Mountain Valley Pipeline Project

Docket No. CP16-10-000

Attachment DR4 General 3a

Re: Burnsville Lake, Braxton County, Mountain Valley Pipeline, LLC - Easement Request
Docket No. CP16-10-100

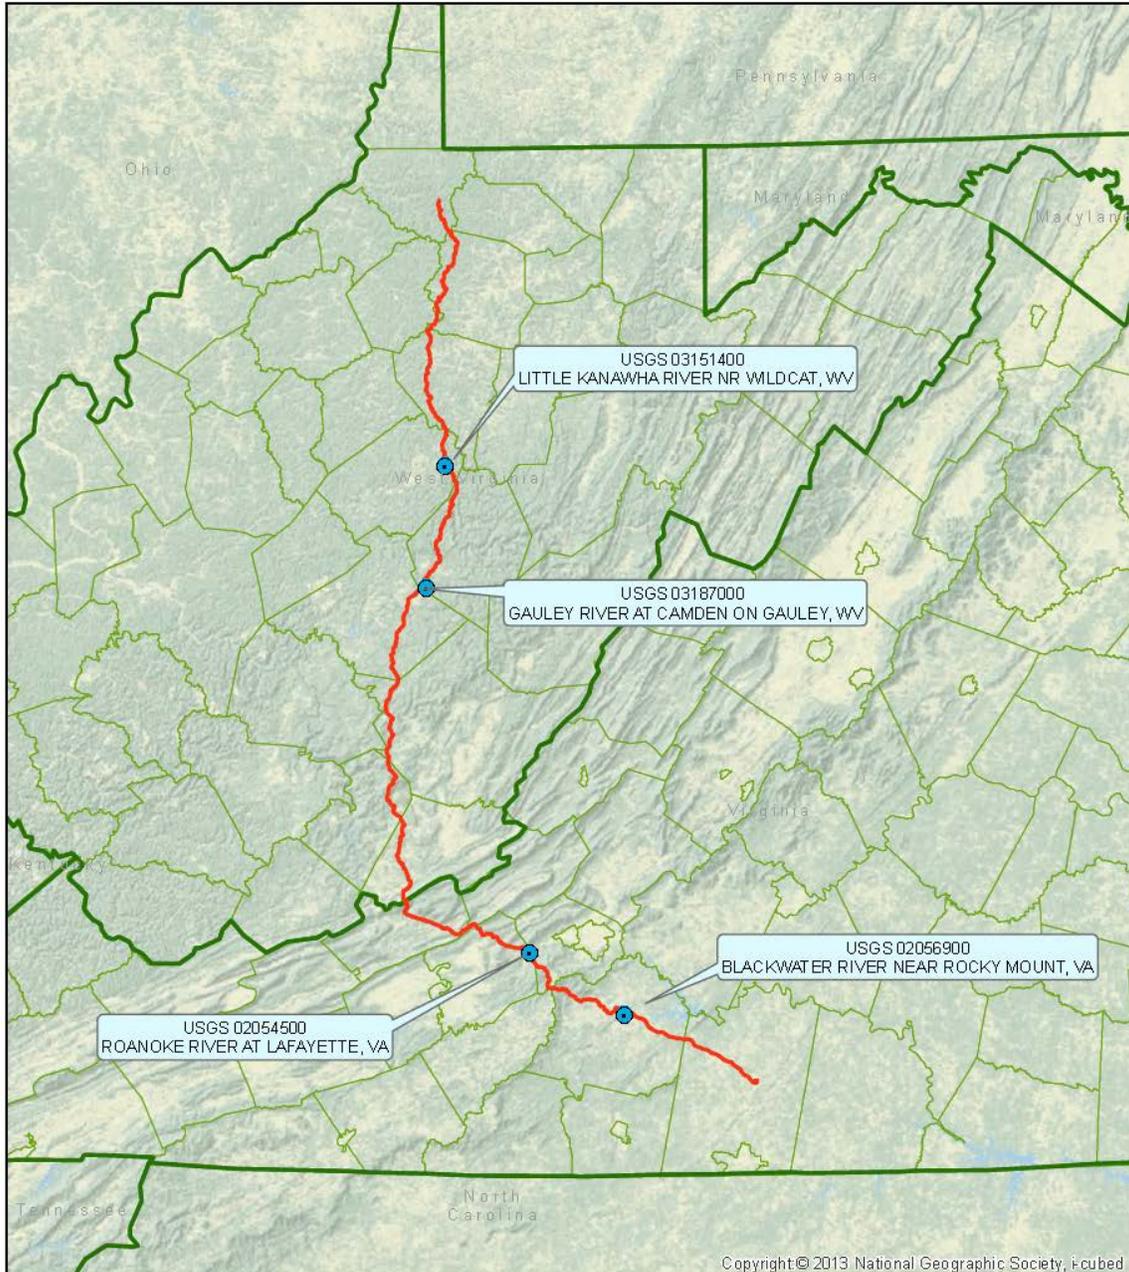
USGS Comment No. 1: The USGS operates streamgages along streams throughout the US to collect water quantity and quality data for a variety of purposes. Continuous operation of USGS streamgages is essential for our stakeholders. These streamgages have permanent infrastructure and are vulnerable to disruption when nearby construction or dredging occurs in the vicinity of these stations. Four active USGS streamgages fall in or near the project area. These are station numbers 02054500, 02056900, 03151400 and 03187000 in Virginia and West Virginia.

The draft EIS should list USGS structures as sites to be safeguarded. The USGS Virginia-West Virginia Water Science Center (WSC) should be contacted and given sufficient advance notice before project activities occur near active USGS streamgages. Efforts should be made to both preserve the streamgages and minimize impacts to the data integrity at those sites.

Mountain Valley Response No. 1: The locations of the four referenced U.S. Geological Survey (USGS) streamgages are shown on Figure 1. As shown in Figure 2 through Figure 5, the four streamgages are located approximately 4,000 to 6,000 feet from the proposed alignment. Based on this physical separation between the alignment crossings and the streamgages, there is negligible risk to the USGS streamgages from pipeline construction. Nonetheless, prior to construction, Mountain Valley will document the condition of each of the streamgage facilities for comparison after pipeline construction is complete. Mountain Valley believes that adhering to the measures outlined in the Project-specific Erosion and Sediment Control Plans (ESCP) and FERC's Plans and Procedures will adequately safeguard these streamgages. However, Mountain Valley will consult with the USGS Virginia-West Virginia Water Science Center to develop additional safeguards for these specific four streamgages, if necessary, and in general to safeguard other USGS appurtenances if encountered along the route during construction. Mountain Valley

Figure 6

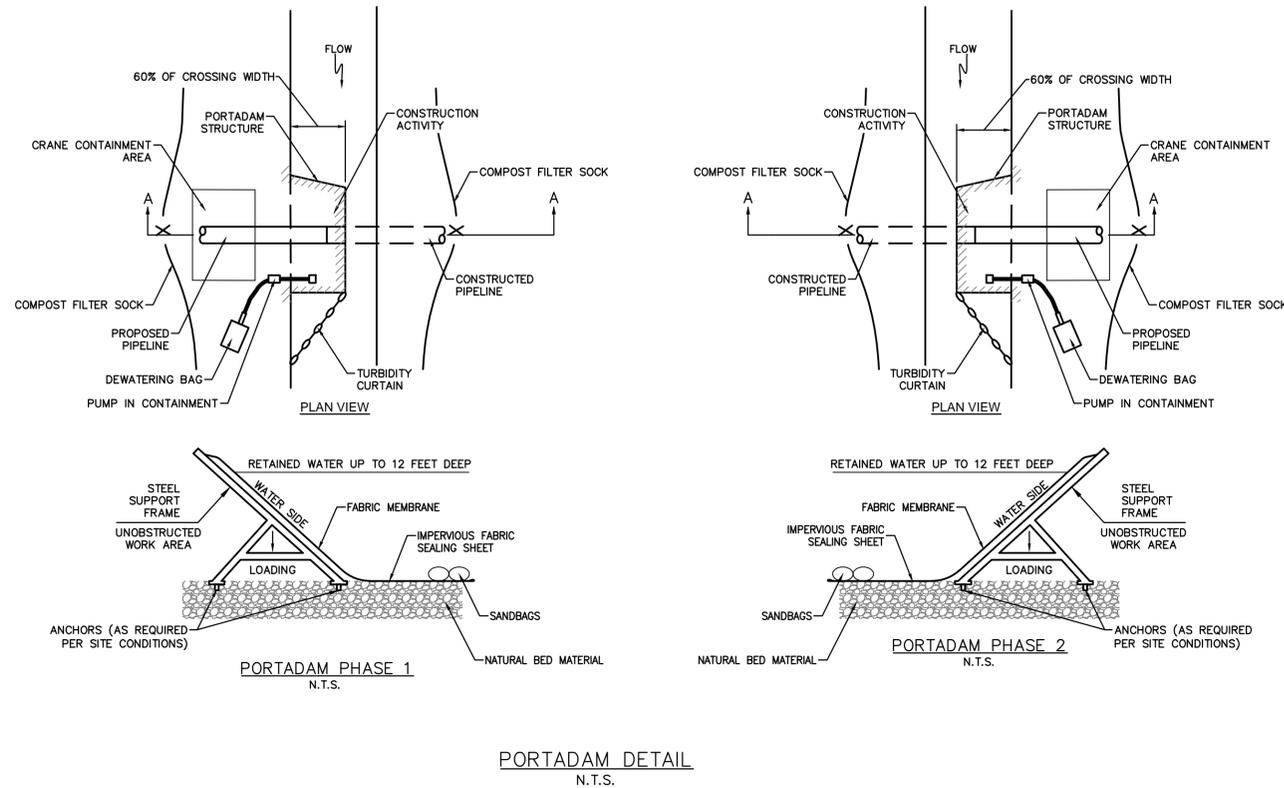
USGS Comment No. 2: Water quality impacts from sediment mobilization due to open cut construction in waterbodies is addressed within the DEIS on pages 4-87 and 4-108. In 2006-2008, the USGS monitored the effects of construction of the Jewell Ridge Lateral natural gas pipeline on turbidity conditions below pipeline crossings of Indian Creek in Tazewell County, Virginia (Moyer and Hyer, 2009). Water-quality conditions were assessed using continuous water-quality monitors deployed upstream and downstream from the pipeline crossings. Adding data collection to the project by employing this successful and relatively simple technique would allow for a rapid response to a major turbidity event. The use of this technique could be especially important at crossings directly upstream of water supply intakes.

The DEIS discusses a review of impaired waters databases and the National Sediment Quality Survey on page 4-94. Transport of particle-associated contaminants, such as bacteria, nutrients, and metals, may accompany elevated sediment concentrations. USGS stream bed sediment samples collected in West Virginia near the proposed Project route show some sites with arsenic concentrations approaching and exceeding EPA Ecological Screening Value of 9.8 mg/kg (EPA, 2006). An analysis of sediment contaminant data from sites near the project should be completed as part of this EIS.

Mountain Valley has proposed to use a dry open-cut technique in place of the wet open-cut construction technique for Elk River, Gauley River, Meadow River, and Greenbrier River identified on page 4-87 of the DEIS. Using the dry open-cut methodology carries less potential for downstream impacts such as sedimentation and turbidity when compared to the wet open-cut method and would greatly reduce the potential for downstream water quality impacts. Mountain Valley developed a Proposed River Crossing Methods summary sheet for these rivers in West Virginia and provided this information to the West Virginia Department of Environmental Protection. The MVP Proposed River Crossing Methods document (Exhibit

A) and construction detail (Figure 6) are included as attachments to this response.
